COMMUNICATION - COMMITTEE OF THE WHOLE - JUNE 20, 2017

ITEM NO. 12, REPORT NO. 26

OFFICIAL PLAN AMENDMENT FILE OP.14.007 ZONING BY-LAW AMENDMENT FILE Z.14.028

ROCCO TATANGELO, JOSEPH FALLETTA, RAVINDAR SINGH MINHAS WARD 4 – VICINITY OF PINE VALLEY DRIVE AND HAYHOE AVENUE

# Conceptual Site Plan Part of Lot 10, Concession 7

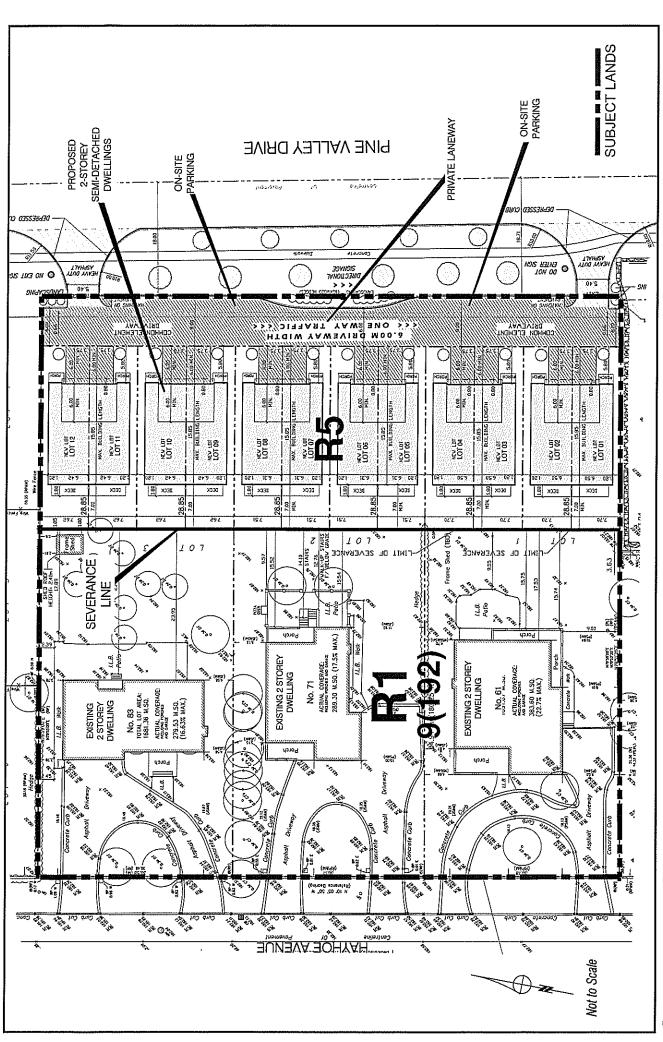
The Committee of the Whole will be considering applications for amendments to the Official Plan and Zoning By-law (Files OP.14.007 and Z.14.028) on June 20, 2017 (Item No. 12, Report No. 26). The staff report includes Attachment #3 — Conceptual Site Plan, which should be replaced with an updated Attachment #3 which is appended to this Communication.

The proposed modification will allow an increase in the drive aisle pavement width from 7.2 m to 8 m, thereby allowing the development to function with a municipal pavement standard that will accommodate required landscape treatment. This change would allow for additional on-street parking and flexibility with directional traffic movement, and additional landscape treatment. As a result of the revised driveway width the following exceptions to the minimum lot area and front yard encroachment to the covered porch are required:

- Minimum Lot Area = 216 m<sup>2</sup>
- Covered porch to encroachment a maximum of .5 m into the front yard

The final design details will be refined during the finalization of the Site Development application including the landscaping treatment and road design. The final implementing zoning by-law will include the exceptions listed above in order to allow the proposed development to proceed while ensuring additional compliance for the existing lots.
